Replacement System Variance Request

APPLICANT'S NAME: Elbridge Lacasse

SUBSURFACE WASTEWATER DISPOSAL SYSTEM APPLICATION

Subject: Approval, Replacement System Variance Request, Lacasse Property, Route 105, Augusta

SITE PLAN Scale 1" = 50' Ft.

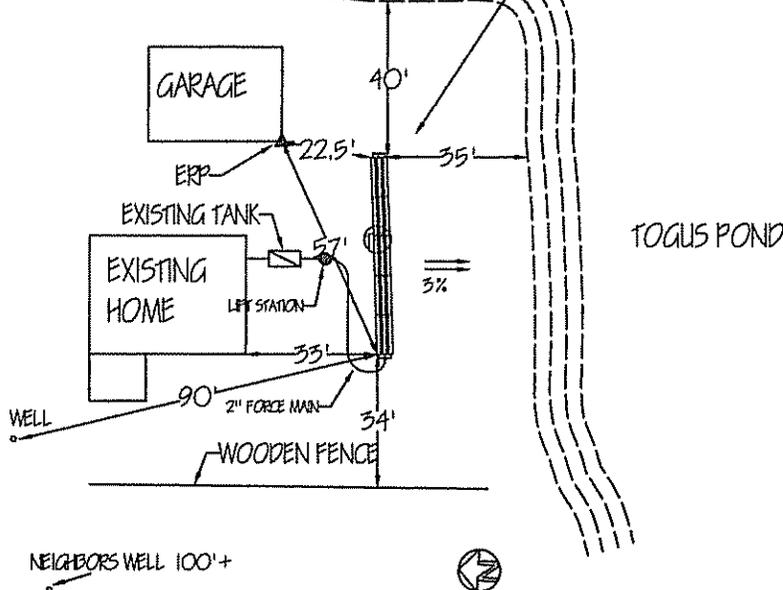
We have completed our review of an HHE-200 Form dated 11/125/06 by Paul A. Beers, S.E. for your property at Togus Pond. You are proposing to replace a trench system, with a disposal area comprised of three rows fabric wrapped pipe, 50 feet long, each. An existing septic tank would continue to be used. The following variances to the Maine Subsurface Wastewater Disposal Rules, CMR 241 are requested:

1. To install a disposal area set back 90 feet from the owner's well.

1. To install a disposal area set back 35 feet from the normal high water mark of a major water body pursuant to Section B.2.b of the Division's *Policy Regarding Replacement System Variances in Close Proximity to Waterbodies/Courses and/or Wells*.

By copy of this letter we hereby authorize the Local Plumbing Inspector to issue a permit for the replacement system installation as proposed on the above referenced HHE-200 Form, with the following conditions:

1. The existing septic tank shall be inspected for volume, condition, and due to proximity to the pond, water-tightness prior to use of the proposed disposal area. If found lacking in any of these criteria, a new septic tank conforming to the Rules shall be installed
2. The fill extensions shall be immediately stabilized with coco-mat or a similarly effective material, and silt fence shall be installed between the fill extensions and the normal high water mark in conformance with industry accepted practices.
